CRYSTAL RESIDENCES PLANNING DIVISION APPLICATION TABLE OF CONTENTS

4-20-2026

City of Coral Gables Planning Division Application

Re: Crystal Residences / Statement of Use / Planning Division Application / Property located at 110 Phoenetia Avenue, Coral Gables, Florida (Folio No. 03-4108-009-1840) (the "Property")

A-1.07

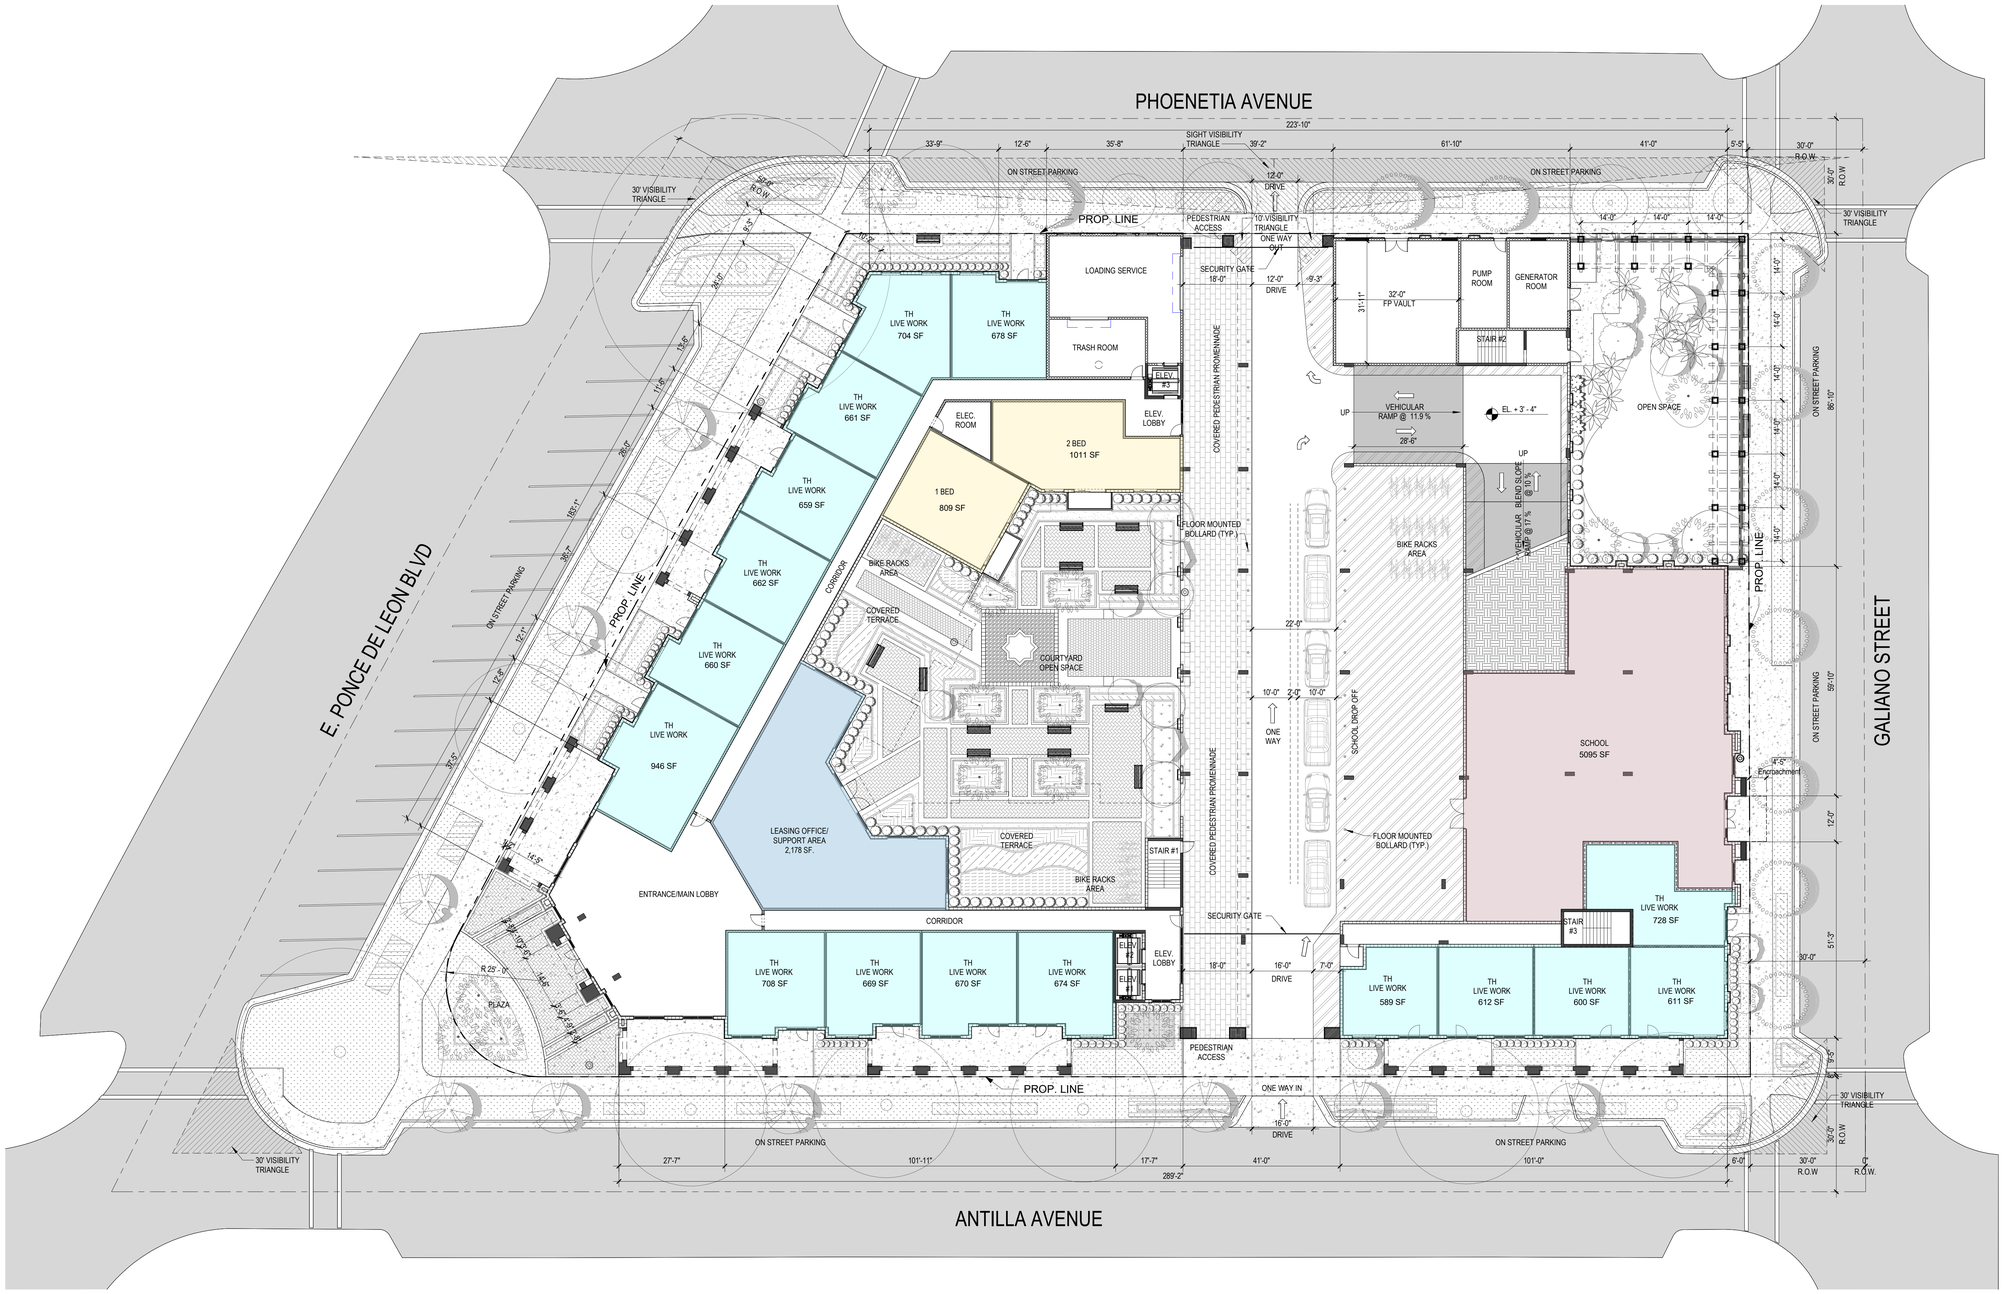
2. School's entrance canopy cantilevers into the right-of-way. Include the encroachment request to the City Commission with this submittal.	Encroachment specifications have been added; please refer to enclosed Sheet A-1.07 of updated Architectural Plans.

As reflected on Sheet A-1.07 of the Site Plans, the Project includes limited building encroachments along the southeast portion of Galiano Street. Specifically, the school's entrance canopy cantilevers into the sidewalk by approximately 4'5" and is elevated at a height of 15'8", ensuring it does not interfere with pedestrian access, walkability, or the circulation of the public sidewalk.

SITE GROUND FLOOR PLAN

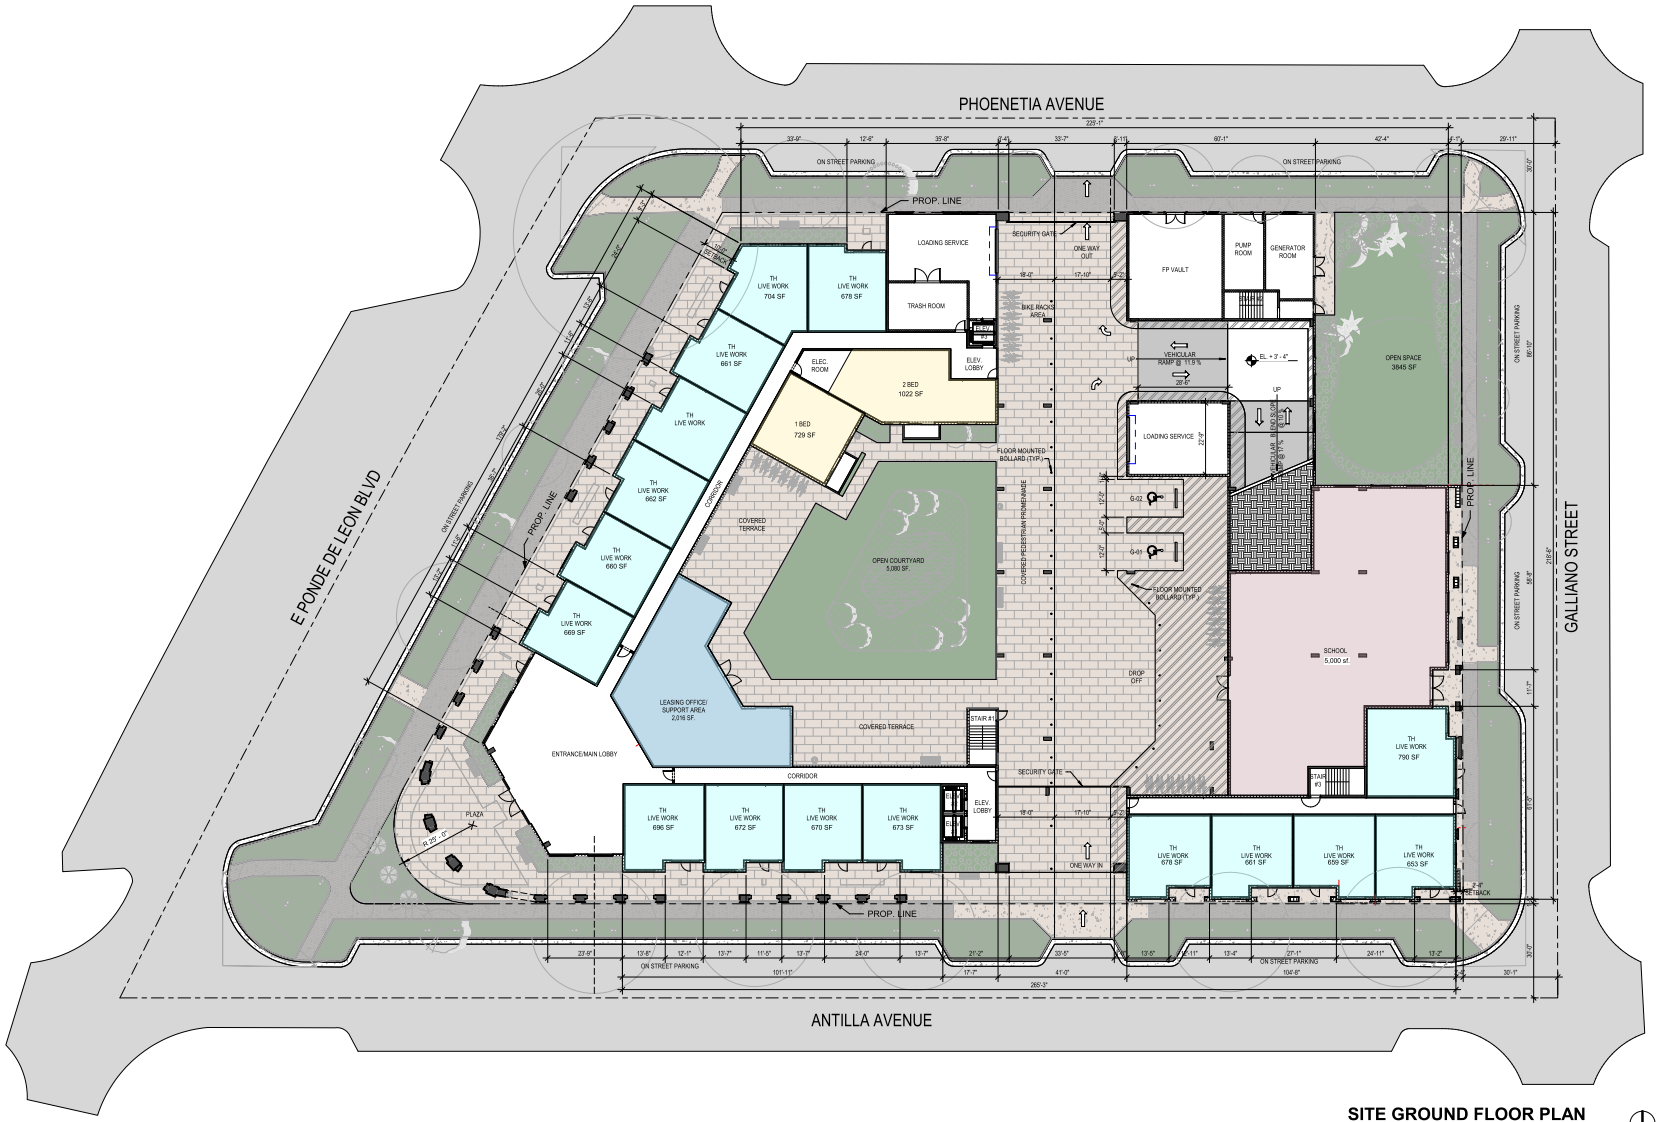
6. TH unit on Galiano (691 SF) detracts from the school's front façade/entrance feature. Remove and adjust as needed.	Adjusted, please refer to updated Sheet A-2.00 of enclosed Architectural Plans.

- Bike racks should be installed wherever retail entrances are located and near the public areas. ***Noted: proposed bike racks located at the ground level public areas including covered terrace areas and paseo promenade as reflected on Sheet A-2.00***.

- **7.** Bumpouts required at the driveway entrance and exit. ***Noted: Bumpouts are proposed for the driveway entrance and exit along Phoenetia Avenue and Antilla Avenue as reflected on Sheet A-2.00.***

- **8.** Visibility triangle is obstructed at Phoenetia Avenue where the driveway exit meets the sidewalk. ***Noted: visibility triangles have been added at each intersection and driveway entrance and exit along Phoenetia Avenue and Antilla Avenue as reflected on Sheet A-2.00.***

10. Bike racks perpendicular within the paseo isn't going to work; relocate
    Noted: Proposed bike racks are located at the ground level public areas, including covered terrace areas and the paseo promenade as reflected on Sheet A-2.00.

11. Remove all bump outs that are not at the street intersections, especially the lengthy bumpout at the southeast corner of the site
    Noted: Please refer to Sheet A-2.00 for the revised ground floor site plan, including the reduced bumpout on the SE corner.

MIXED USE DIAGRAM

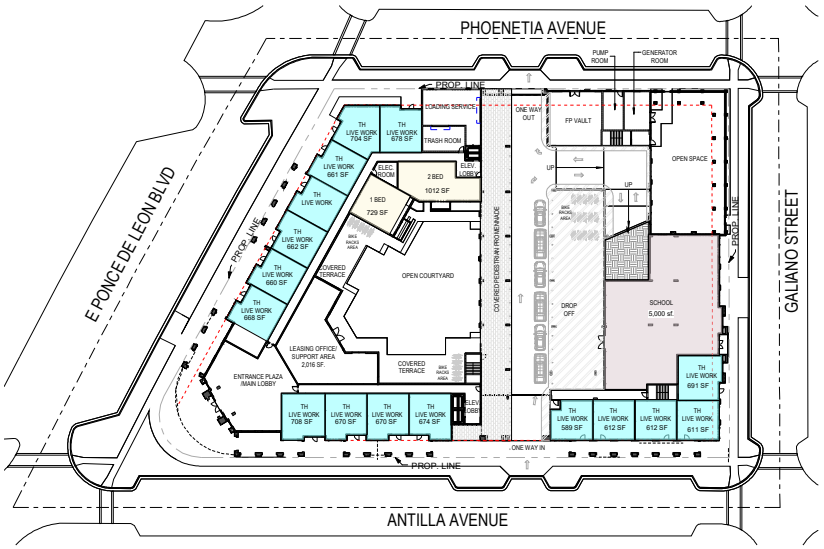
- Update Project Data on sheet A-1.03 with the following: **(1)** Include proposed maximum building coverage; **(2)** Add N/A stepback requirements for existing zoning (S); **(3)** Update Bicycle parking requirements: per Section 10-110, Bicycle parking shall be provided at a minimum of one (1) bicycle space per four (4) residential units and one (1) bicycle space per twenty thousand (20,000) square feet of non-residential use building area; **(4)** Update Mixed-Use requirements for mix of uses to Section 2-201.B(3); **(5)** Add the percentage of square feet for the mix of uses in parenthesis; and **(6)** Update spelling to "Galiano" and "East Ponce de Leon"
  Noted:
  (1) The proposed maximum building coverage is provided on Sheet A-1.03.
  (2-5) The Project Data Table has been updated and is provided on Sheet A-1.03.
  (6) Spelling has been corrected.

3. The PAD specifies certain "statistical information" be included, including "building coverage expressed as a percentage of the development site area" I understand that there is no maximum requirement for the proposed MX zoning, but I am still requesting inclusion of this information. ***Noted: proposed building coverage has been added to Sheet A-1.03.***

4. The current zoning "S" has setback requirements; it's the stepbacks that are N/A; Please include the existing setbacks in the zoning data. ***Noted: The existing setback/stepback requirements under the Special Use zoning designation have been added. Please refer to Sheet A-1.03.***

5. Remove the mixed use info under the existing "S" column. ***Noted: Removed, please refer to Sheet A-1.03.***

TREE DISPOSITION PLAN

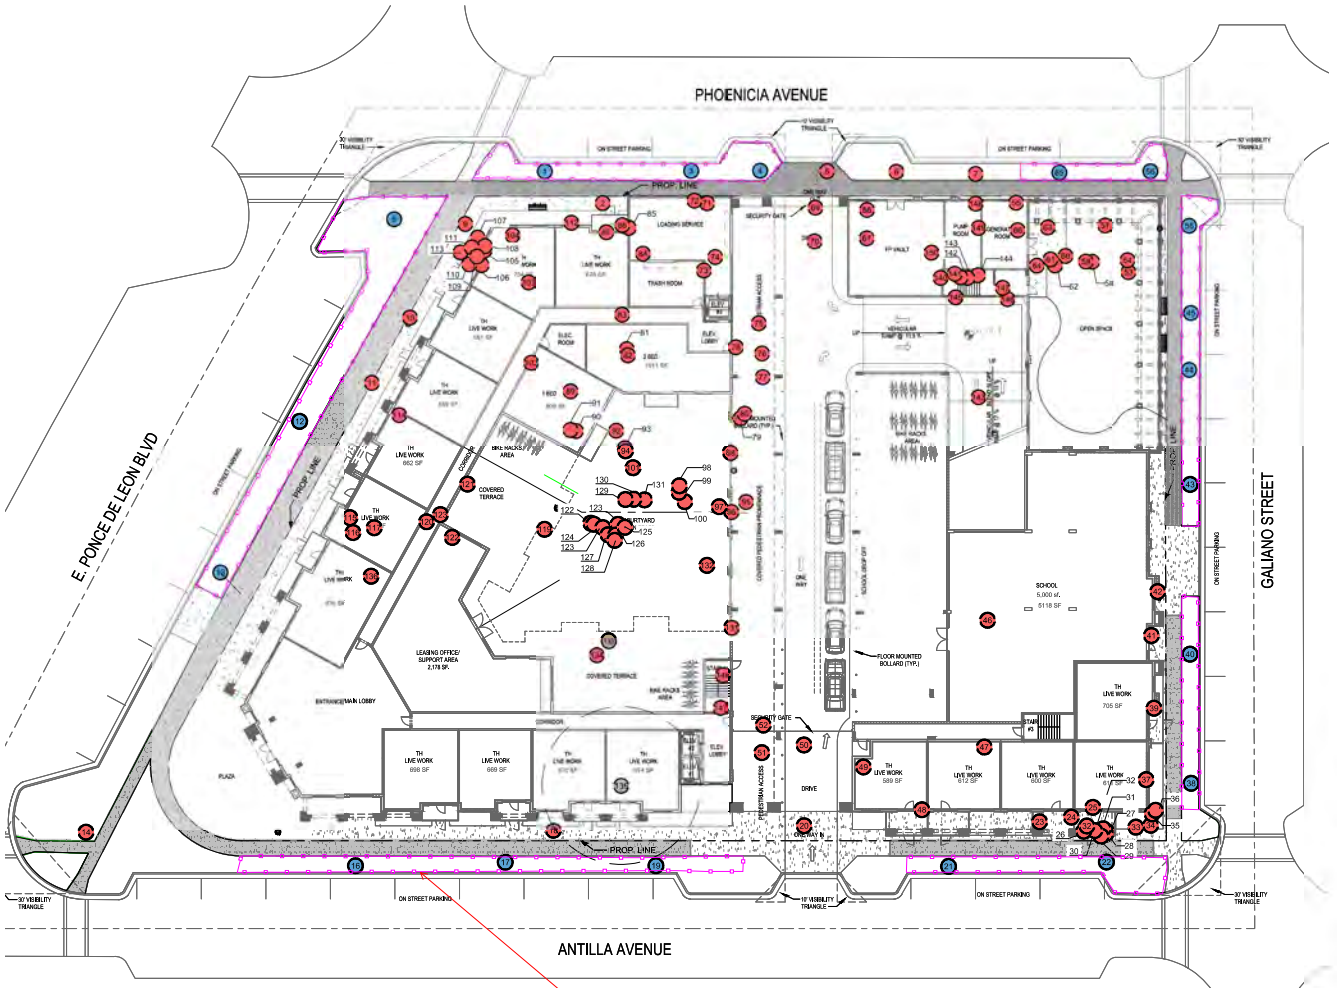
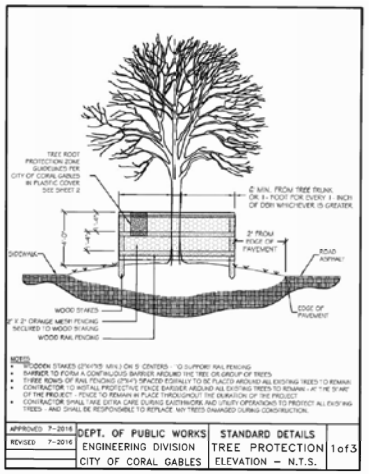
- Greenspace Management Corrections - See comments in corrections for submittal with the building permit.
    - Provide a tree survey of existing trees on site and right of way. Refer to section 82 of the city code.
      A tree disposition plan and relocation plan has been submitted that reflects the protection plan for on site trees (Sheets TD-1 and TD-2).

- Provide existing tree disposition plan outlining mitigation and protection.
      A tree disposition and relocation plan has been submitted that reflects the protection plan for on site trees (Sheets TD-1 and TD-2).

- Provide a tree survey and tree protection plan
  Noted: Tree survey and protection plan is provided on Sheets TD-1 and TD-2.

1. Where are sheets TD-1 and TD-2? Showing the existing trees for this project is very important. ***Noted: A tree disposition and relocation plan has been submitted that reflects the protection plan for on site trees (Sheets TD-1 and TD-2)***.
